**Memorandum**

**TO:** District of Columbia Zoning Commission

**DATE:** September 23, 2013

**SUBJECT:** **ZC 06-04 C- Modification** –Florida & Q Street, LLC - 1600 North Capitol Street, N.W. (Square 3100, Lot 48).

#### Revised Elevation 06-04C (5/31/2013)

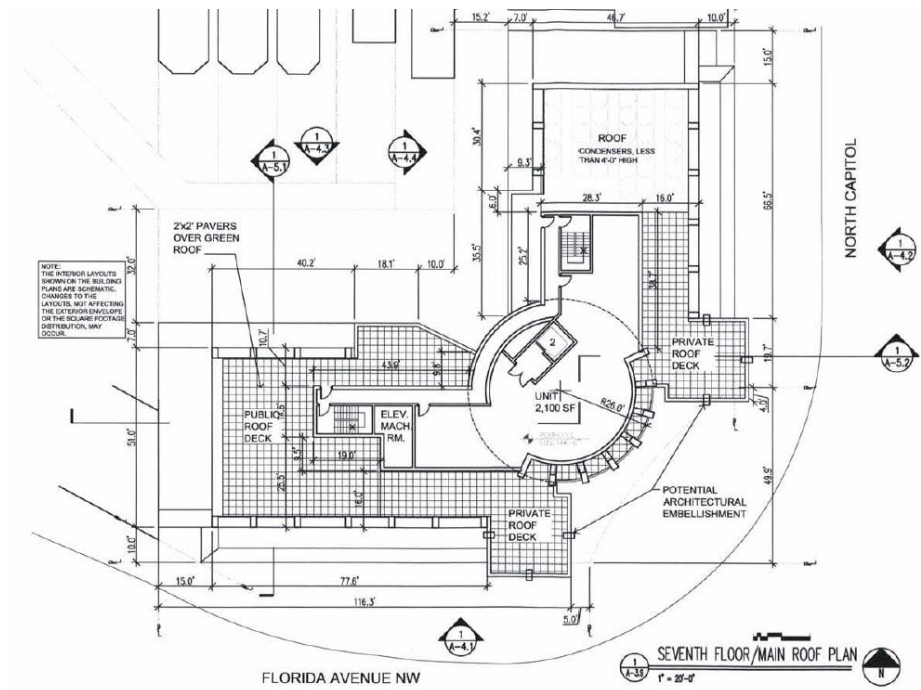
There is a visible grade change at the front of the building which shows a lower entrance and lobby area. The tower element has been revised. (See A-1.5 for street perspective)

**Modified Plan (Sheet A 3.8 (9/13/2013))**

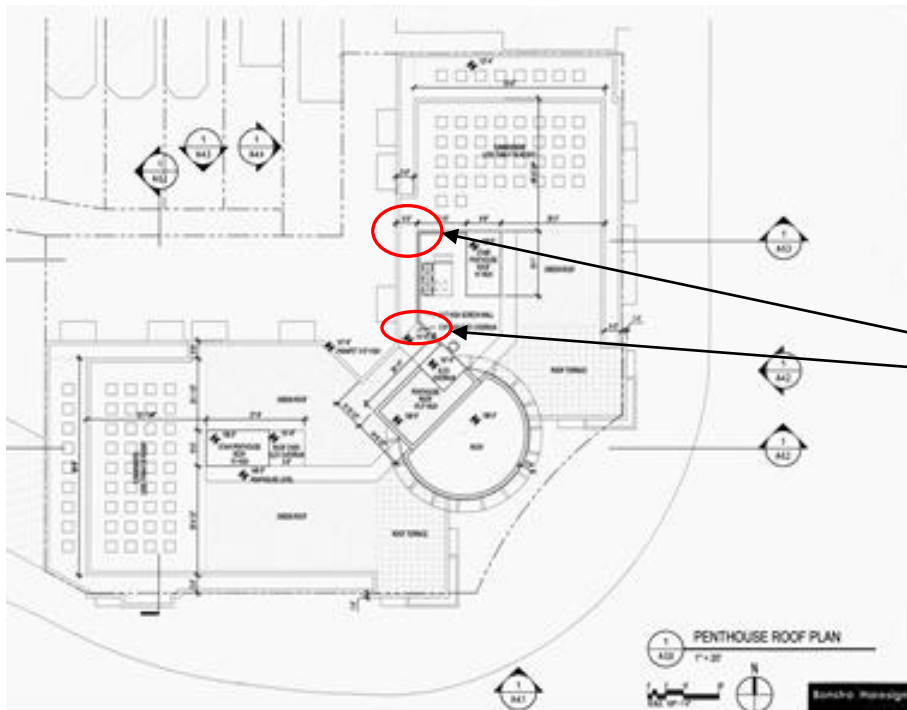
The upper level roof plan shows less area devoted to roof decks, relocation of green roof areas and installation of more rooftop condensers.

Flexibility requested from roof structure requirements in these locations.

This request involves multiple roof structures of uneven height, two of which are not set back a distance equal to its height above the roof (*Sheet A 3.8 9/13/ 2013*). The multiple roof structures with uneven heights, including those of the stair towers and elevators to the roof serve to minimize the massing on the roof at a prominent corner. The two stair towers would satisfy Building Code requirements for a separate egress for each wing of the apartment building. The drawings show – the elevator enclosure behind the tower and the 9ft-high screen wall - not set back from the courtyard wall a minimum of 10 feet as required. This would not adversely impact the availability of light and air to neighboring structures. OP has no objection to the flexibility requested.
